ABP— 314485-22

Planning Appeal Online Observation

Observation on a Planning Appeal: Form.

Dublin Airport, Co Dublin

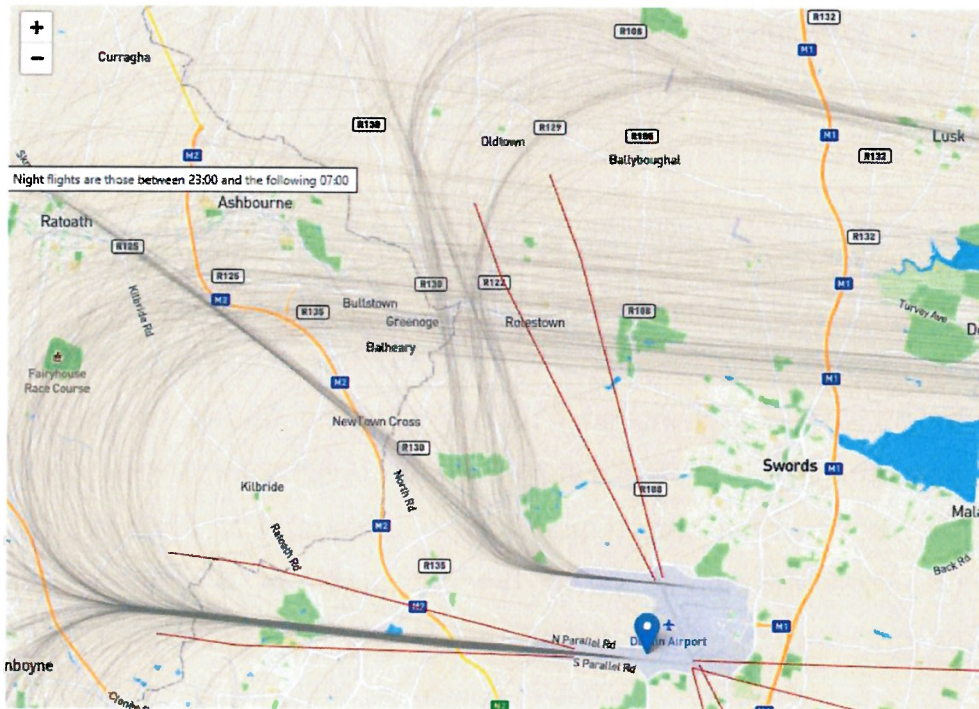
4. Divergent flight paths are proposed but these are dramatically different to the flight paths being implemented at Dublin Airport since the North Runway opened. How can any of the applicant's forecasts be trusted if they cannot determine the flight paths to use on their own runway? An Bord Pleanála should investigate the impact of changing the flight paths on the environment.

- Departures on North Runway on August 25-27th and all dates of westerly departures since opening are showing divergent routes contravening the planning permission from 2007
